Docket No. 50-289

SUBJECT: TMI ACTION ITEM II.K.3.30

SAFETY EVALUATION REPORT
FOR THE
BABCOCK AND WILCOX OWNERS GROUP
SMALL BREAK LOSS-OF-COOLANT ACCIDENT
EVALUATION MODEL, CRAFT2 (REV. 3)
(BAW-10092P, REV. 3 AND BAW-10154)

Figure 2. Comparison of CRAFT2 to RELAP5. RELAP5/MOD2 sensitivity study on percentage of steam generator tubes wetted by AFW.

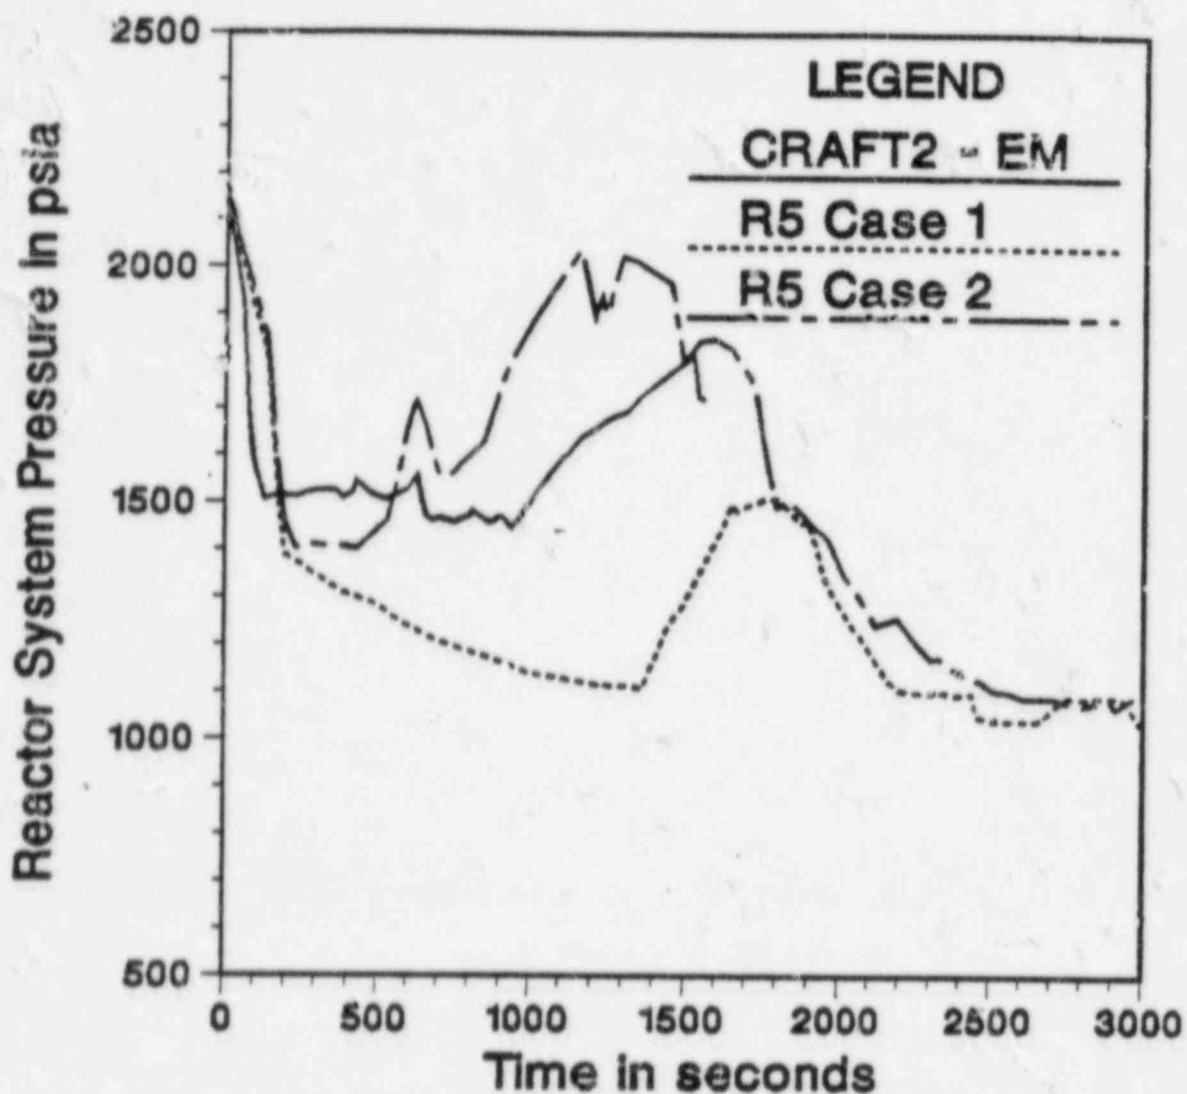
Recently completed analyses performed by the NRC with the RELAP5/MOD2 computer program have been qualitatively compared to the B&W CRAFT2 results for a 0.01 square foot cold-leg break (Reference 15). While this study was not intended to be a direct audit analysis, input assumptions were selected to explore the effects of natural circulation, reactor system repressurization, and boiler-condenser heat transfer including the effectiveness of Auxiliary Feedwater (AFW) spray on the upper OTSG tube elevations.

The RELAP5/MOD2 analyses indicated that although AFW wetting effectiveness can influence the primary system response, the general trends are unaffected. The analyses demonstrate that repressurization can occur during a small break LOCA at a B&W lowered-loop plant. Figure 2 provides a comparison of the RELAP5 results to a similar CRAFT2 analysis. This confirms the B&W CRAFT2 results for a similar size break. The timing of the operator action to raise the secondary system water level to 95% was found not to be critical. Some boiler-condenser heat transfer was found to occur with the level at 50% of the operating range, which terminated the increase in the reactor system pressure before the level was raised to 95%. Finally none of the conditions examined led to core uncover or heat-up.
